Revised February 4, 2016

**Re: Site Management Plan - Addendum 1
Kips Bay Fuel Terminal Site
626 First Avenue
New York, New York
BCP Index No. A2-0515-0405, Site No. C234014
Langan Project No.: 170234201**

SMP Modification

FOUNDATION PLAN
(CELLAR LEVEL 2)

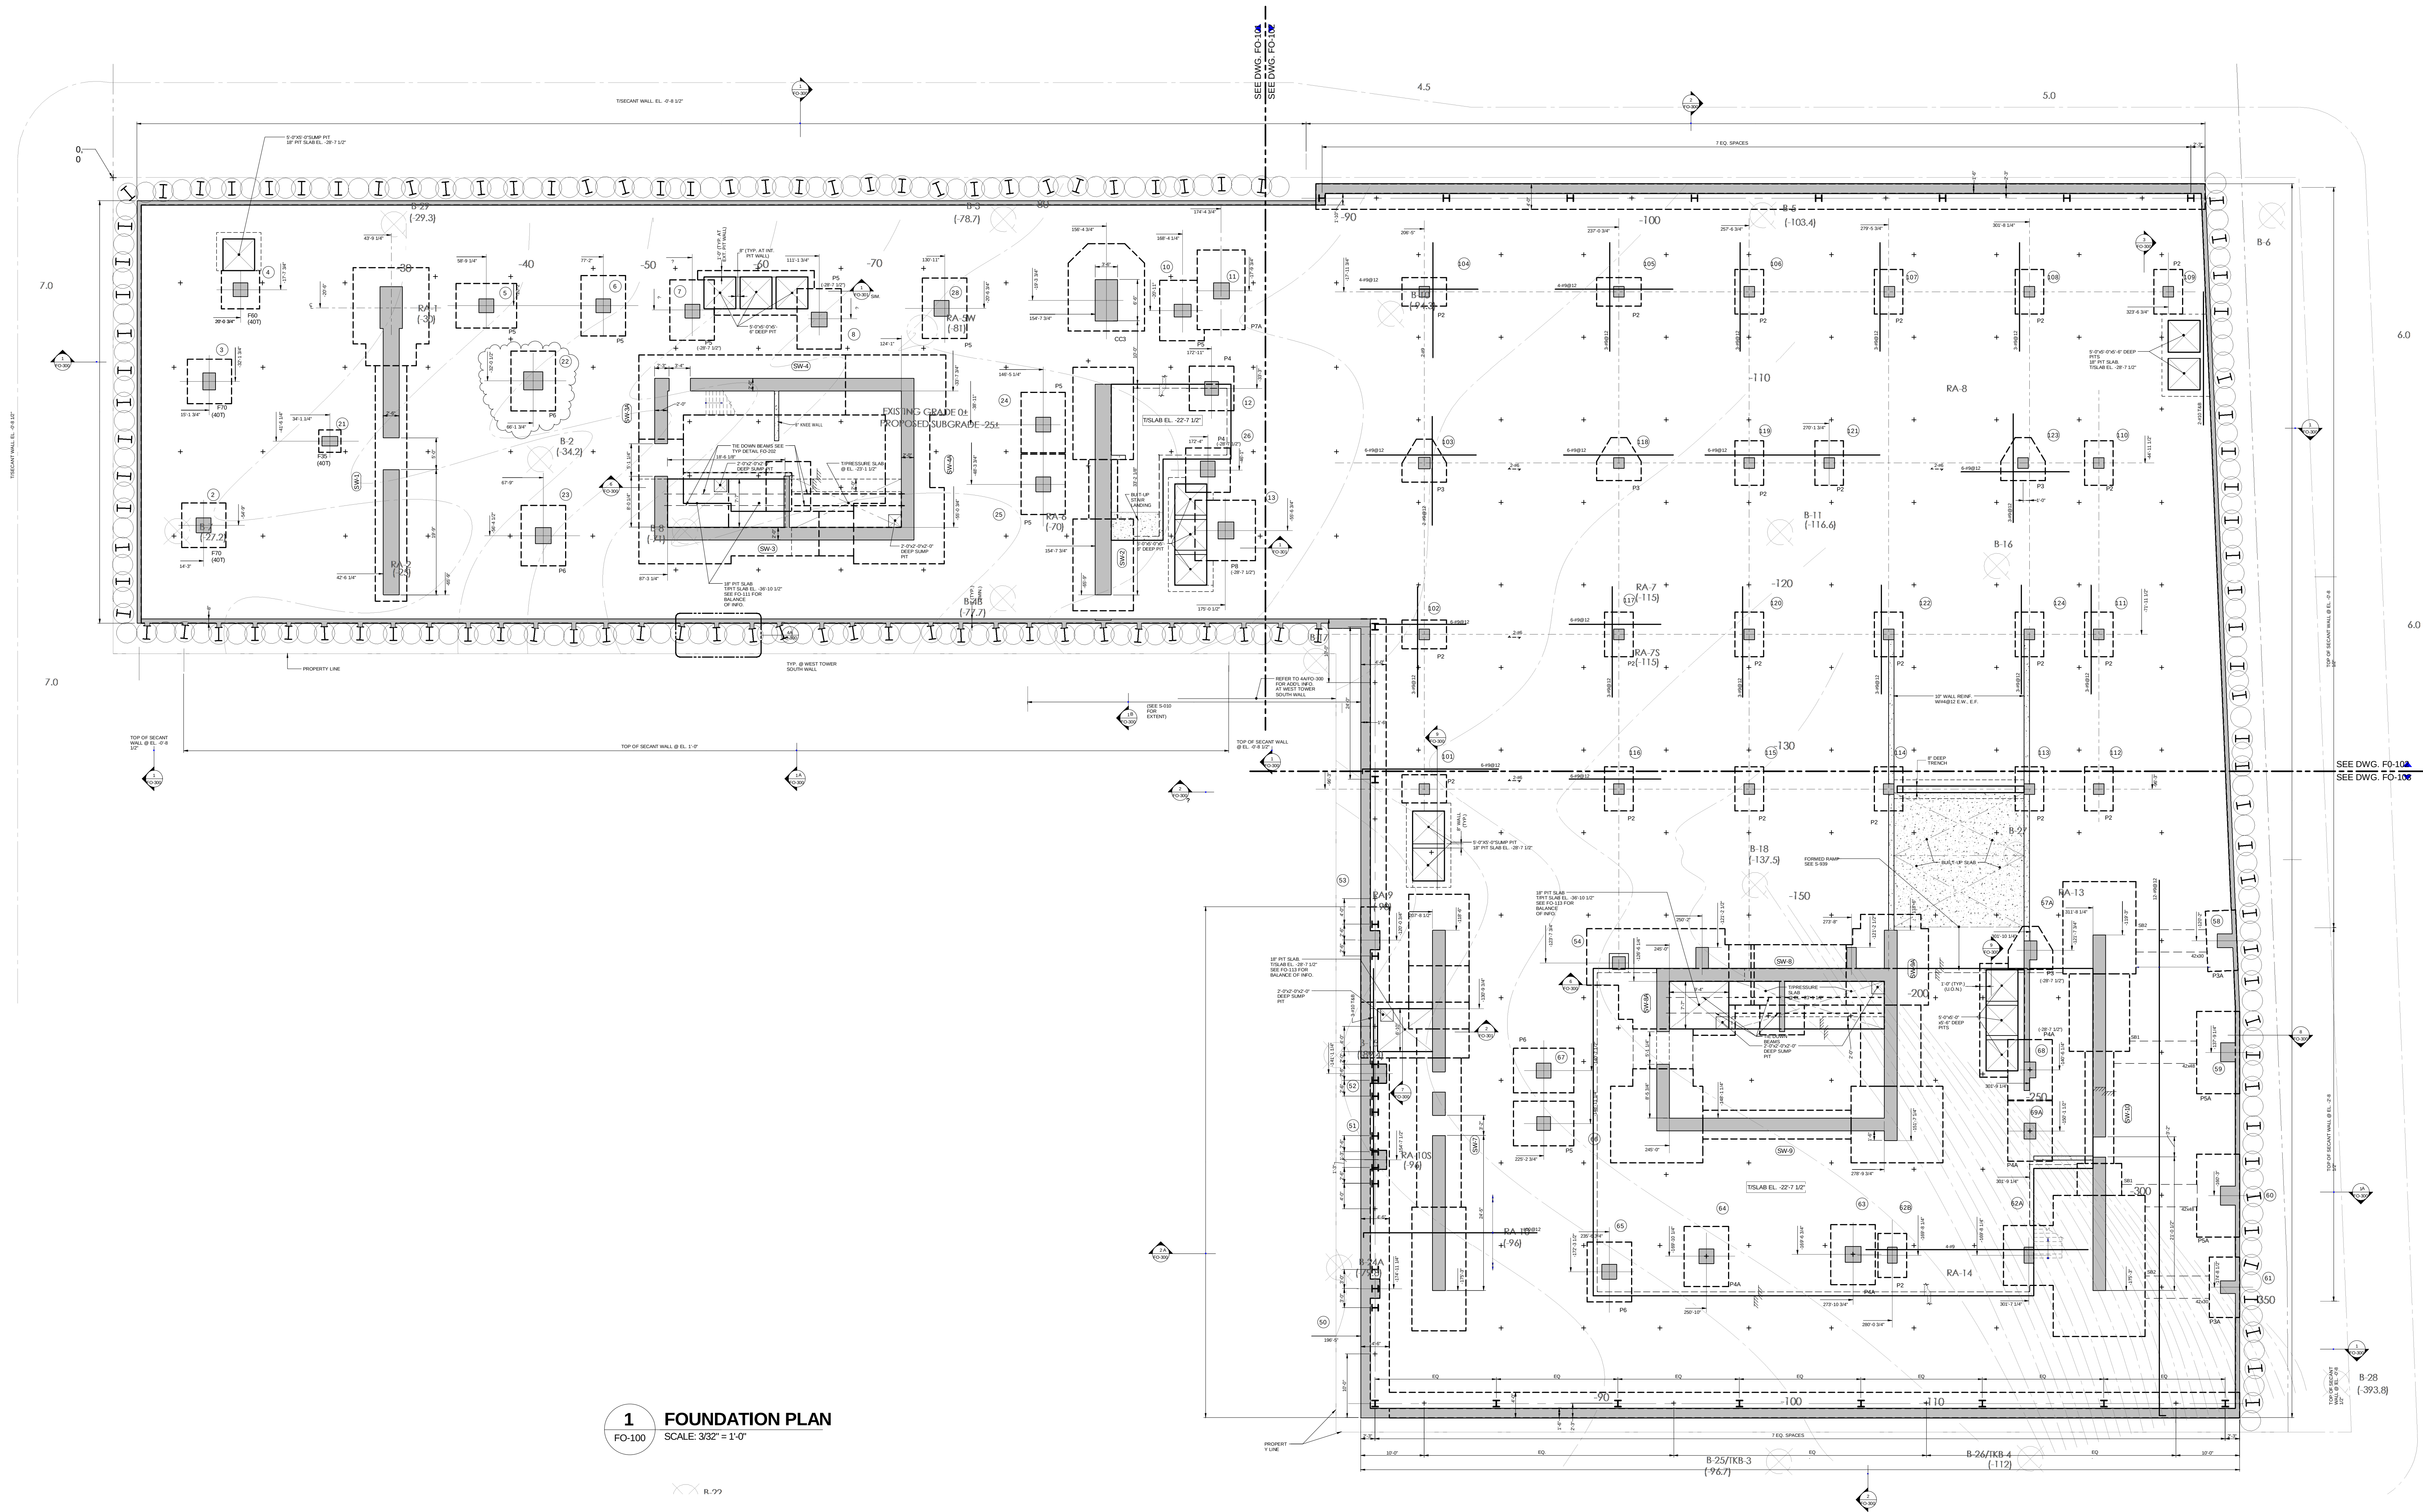
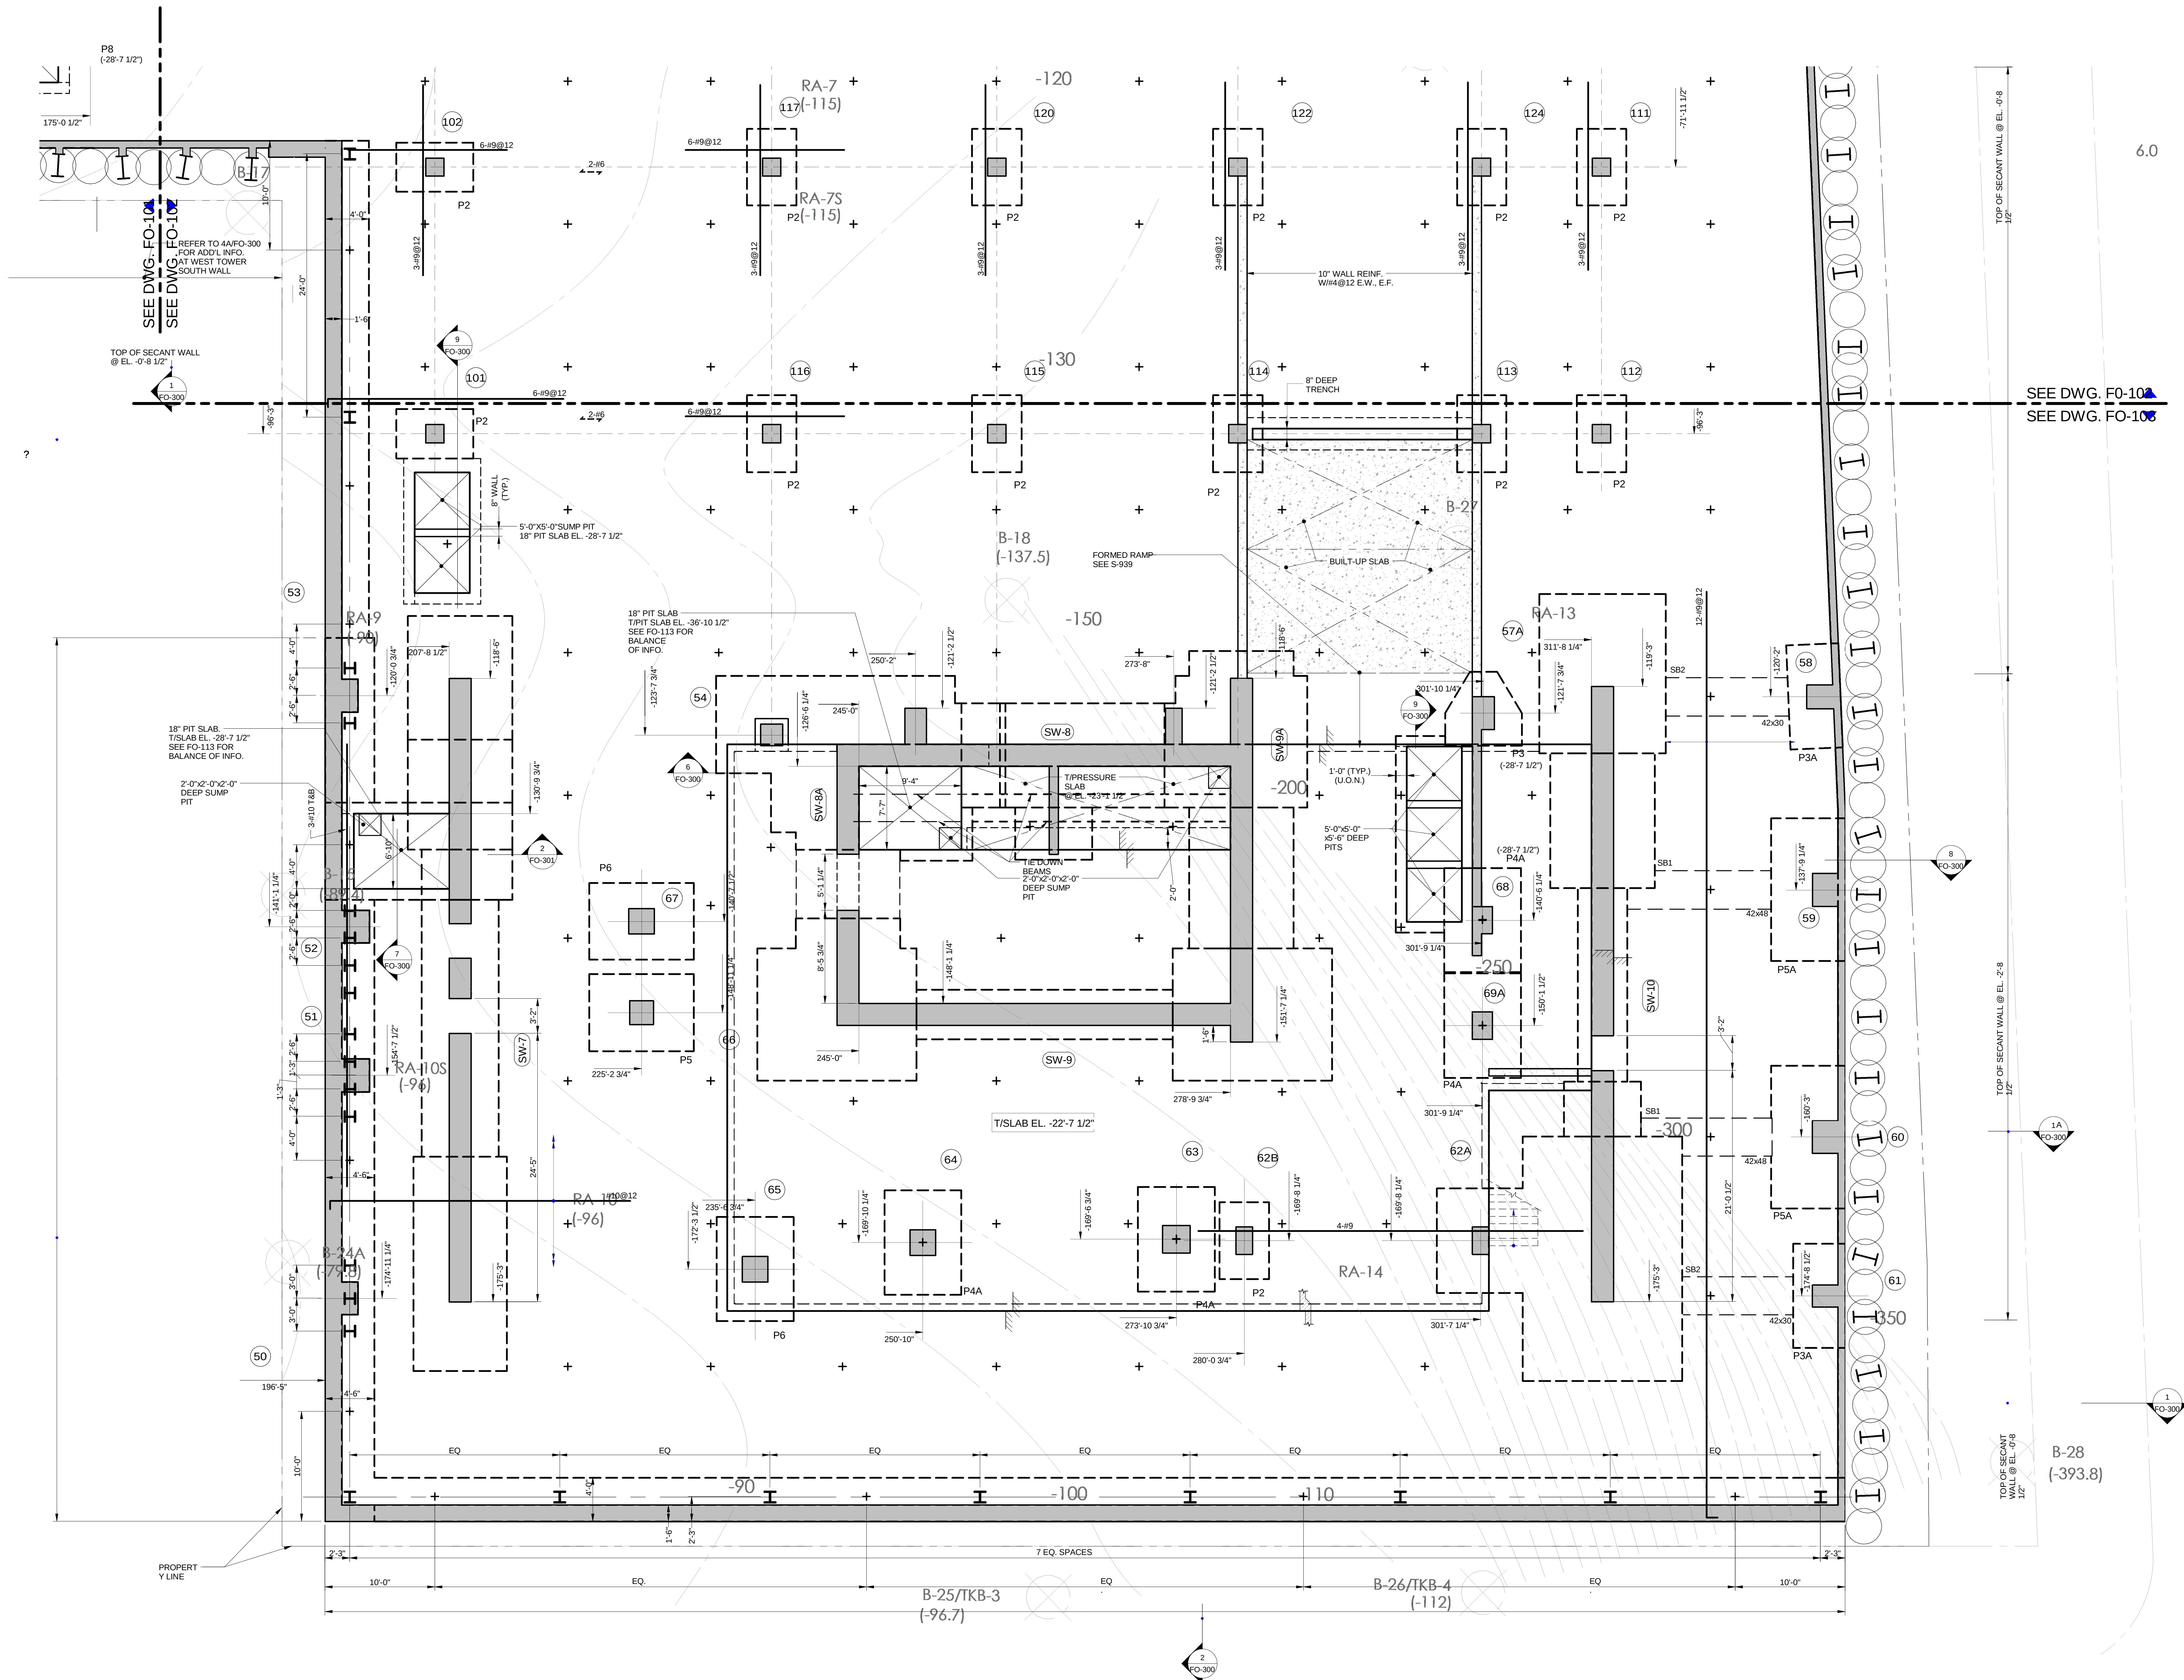
higher. We propose to redefine the Development Depth on Lot 1 as the bottom of foundation on the attached foundation drawings (Attachment A). Based on final excavation depths as part of site redevelopment, the Development Depth ranges from el. -21.975 to -36.725 NAVD88). Intrusive activities that disturb the waterproofing and soil beneath the foundation will be subject to the provisions of the SMP. This proposed modification to the Development Depth supersedes the fifth paragraph of Section 1.0 (Introduction & Purpose), the first paragraph, second sentence of Section 5.4 (Cover System), and all references to Development Depth in the NYSDEC-approved September 2011 SMP. No changes to the Development Depth are proposed for Lot 2 at this time.
